Mussetter Engineering Inc.

Memorandum

Project: 04-31

Subject: DRAFT Comments for Design Features. Main Branch Calabacillas Arroyo

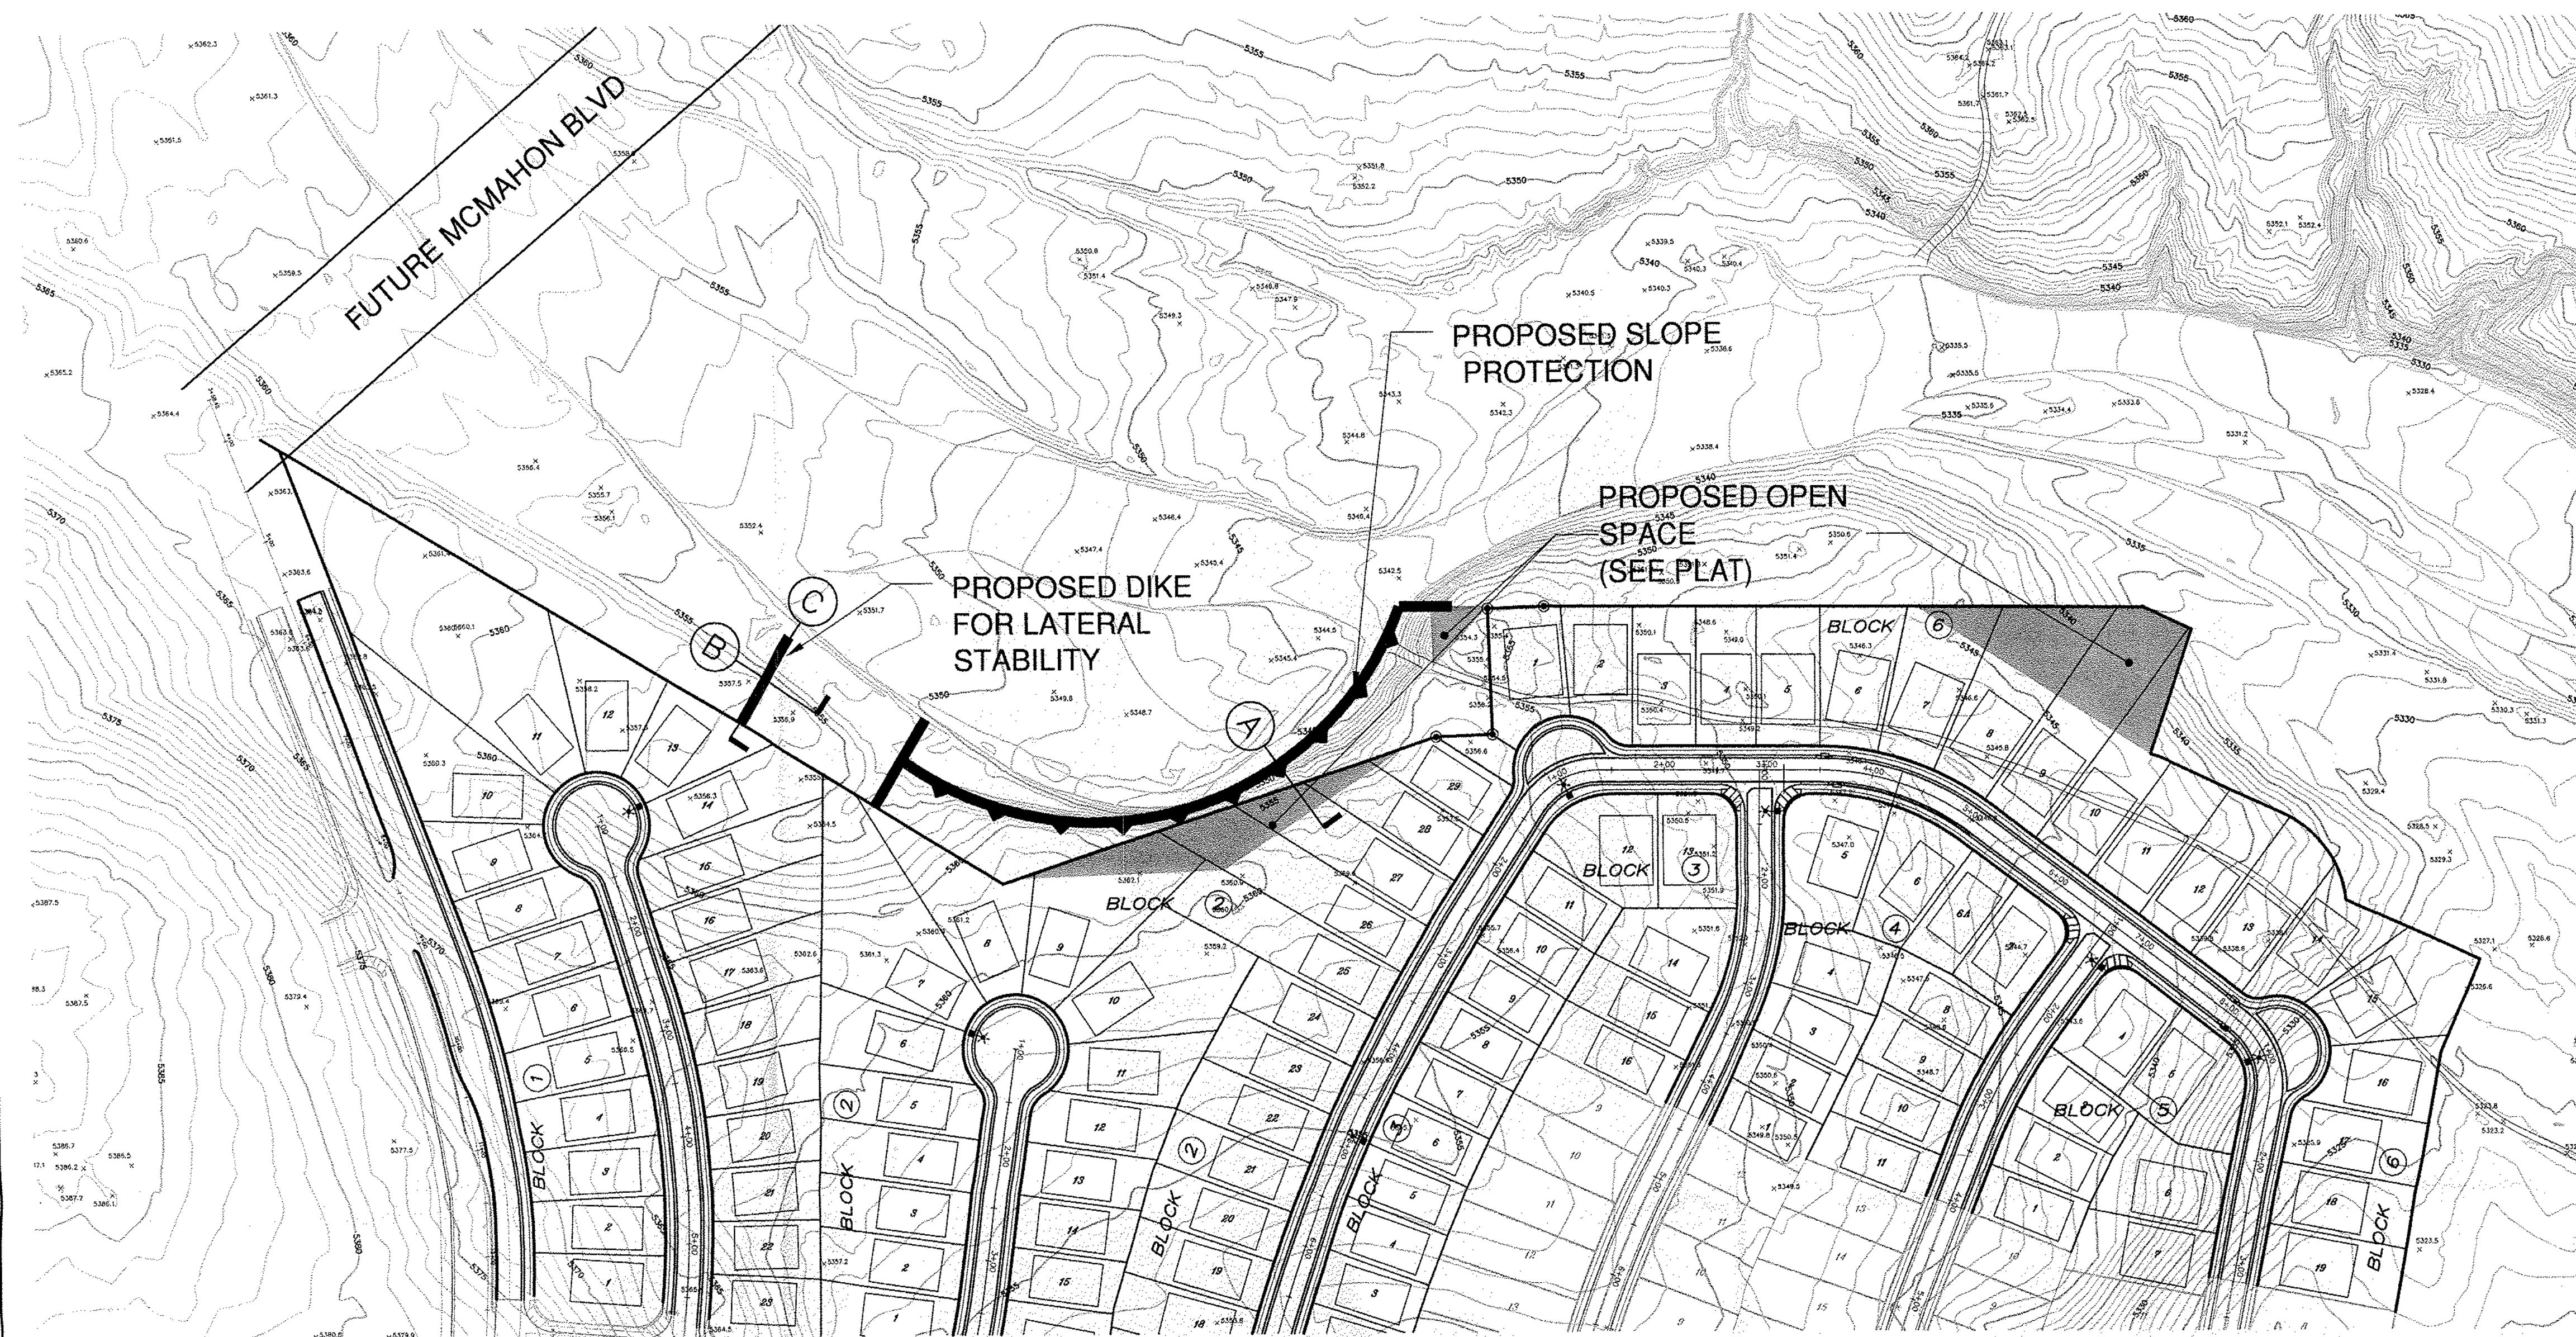
To facilitate the evaluation of project conditions, the various design features, including the spur dikes, grade-control structures, and McMahon Bridge crossing, were overlaid onto the most recent available aerial photography (2000) and topography (2003) (**Map 1**). The spur dikes are labeled 1 through 9 from down- to upstream, with subscript L for the left bank spurs and subscript R for the right bank spurs. The design top of bank was laid out with a channel top width of about 290 feet, based on a channel bottom width between the spurs of 180 feet at the existing bed elevations, 8-foot high spurs at 2H:1V sideslopes, and a spur length of 40 feet. (The 180-foot bottom width is slightly greater than the 165-foot width of the spurs shown on Sheet 1 of 1 on the Goodwin Master Plan.)

The potential erosion setback for the design top of bank was evaluated by comparing the erosion envelope line that represents the maximum lateral migration distance (Δ_{\max}) between the hardpoints (i.e., spurs and grade-control structures) with the flow expansion angle downstream from each structure. The erosion envelope was established based on Figure 3.24 of AMAFCA's Erosion and Sediment Design Guide (Mussetter et al., 1994). Guidelines from the Federal Highway Administration HEC-20 (Lagasse et al., 1995) indicate that, for impermeable dikes with the suggested design geometries, the flow expansion angle relative to the direction of flow is about 18 degrees. For purposes of this analysis, it was assumed that the bank is subject to erosion in any areas that are within the line represented by the expansion angle downstream from each structure and the maximum erosion envelope. Areas where bank erosion could lead to flanking of the design features are highlighted in Map 1. Protective measures for the highlighted areas could include either:

2. Spurs 9L and 9R are located about 550 feet downstream of the right bank tributary outfall that will be protected or reinforced as part of the design. If the right bank spur is located in the channel (Map 1), a significant portion of the right bank fill upstream of Spur 9R will need to be protected. Because Spur 9L is located on the outside of the downstream portion of a large bend, significant tie-back or upstream bank protection will be required.

3. Because the alignment of GCS#4 results in flow impingement on the left bank upstream from Spur 6L, the bank will likely require protection (even if the spur were tied into the bank by the suggested distance of 114 feet). If the structure was rotated counter-clockwise by 10 to 20 degrees, the length of bank protection could be reduced while maintaining proper flow alignment through the structure.

4. The current alignment of Spurs 5L, 5R, and 4L will direct the majority of flow into the upstream face of the right bridge abutment. Improved alignment of the flow into the bridge opening could be achieved by removing or significantly reducing the length of Spur 4L, adding Spur 4R adjacent to Spur 4L, and shifting Spurs 5L and 5R about 70 degrees toward the left bank. (The flow alignment could also be improved by shortening Spur 5L and lengthening Spur 5R).

5. It is MEI's understanding that the entire right bank between GCS#3 and Spur 3R will be protected. To minimize the potential for bend scour below GCS#3, the upstream portion of this bank should be parallel to the direction of flow exiting the structure (see Map 1). Since the bank protection will extend to the upstream face of Spur 3R, it may be more cost-effective to eliminate Spur 3R and extend the riprap a short distance (50 to 80 feet) to a location coincident with the nose of the proposed spur. Spur 3L does not appear to provide significant flow direction or bank protection and could probably be eliminated from the design.

- A. Tying the structure back into the bank beyond the maximum lateral migration distance or limit of the flow expansion angle from the upstream structure, whichever is least,
- B. Protection of the upstream bank to the location where the limit of flow expansion intersects the bank, or
- C. Reducing the distance between the spurs.
